**17/04151/FUL**

**Land Parcel At Upper Rissington  
Upper Rissington  
Gloucestershire  
GL54 2NP**

**Variation of condition 1 of reserved matters permission 12/03810/REM dated 23/01/2013 to provide detailed plans and sections of open space provision and to provide amended plans for hard surfacing and planting at Land Parcel At Upper Rissington Upper Rissington Gloucestershire GL54 2NP**

<b>TITLE</b>		
Upper Rissington NEAP 01 - Country Park		
<b>CLIENT</b>		
Bovis & Linden Homes		
<b>SCALE</b>	<b>DATE</b>	<b>DRAWN</b>
1:400 @ A3	JUN 2013	EM
<b>DRAWING NUMBER</b>	<b>REVISION</b>	
5109/ PS05	E

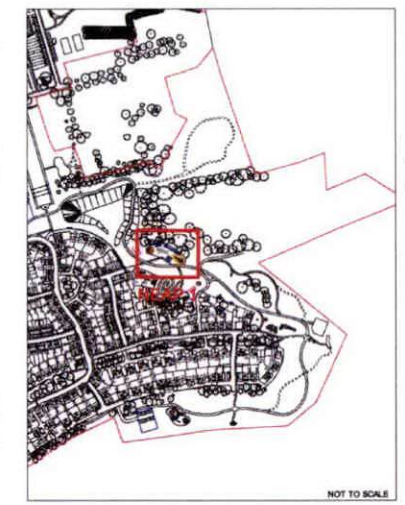
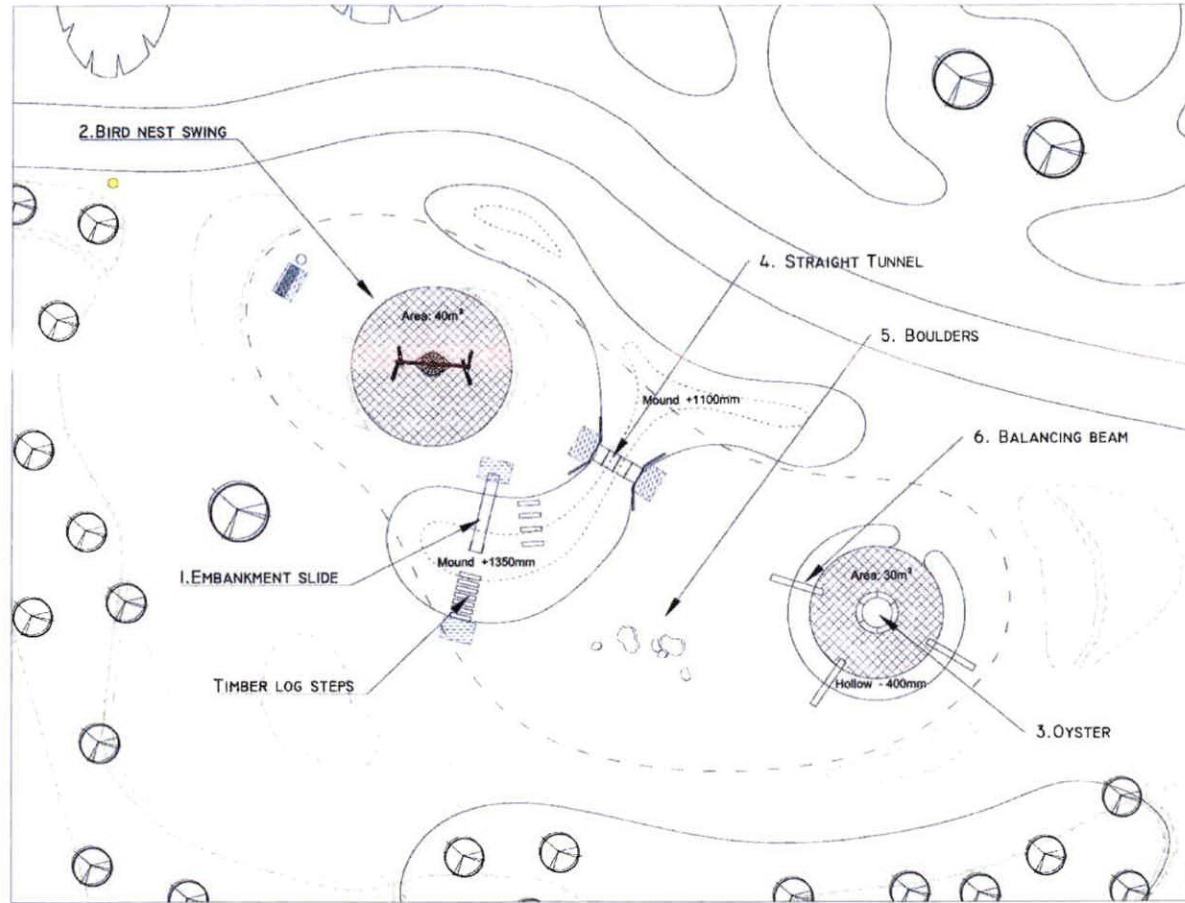
- i. The Country Park NEAP only contains 8 pieces of equipment so we question whether it can be considered a NEAP as it should have 9 pieces;
- ii. The colour of the wet pour rubber within LEAP 03 should be themed with RAF colours;
- iii. Is the trim trail appropriately located given that is principally for use by 5-12 year old age range? Usually a play space for this age range should be fenced off and at least 20m from the nearest window (Six Acre Standard);

- xx. Relocate the play areas on the outskirts of the village and plant trees and wildflower meadows adjacent to houses instead;
- xxi. NEAP1 bears no resemblance to the original plan and should be re-evaluated;

It should be noted that 2 play units within the Neighbourhood Equipped Area for Play (NEAP) which is sited within the eastern part of the application site and to the south-east of the attenuation pond, sit inside of the recommended 30m buffer zone (this is the minimum distance between the equipment and the nearest dwelling); however, it must be acknowledged that the buffer zone set out within the FIT guidance is just that, guidance, and given that these 2 play units are static and that there will be some tree planting within the buffer, Officers consider that the reduced distances would not adversely impact upon the amenities of adjacent properties.
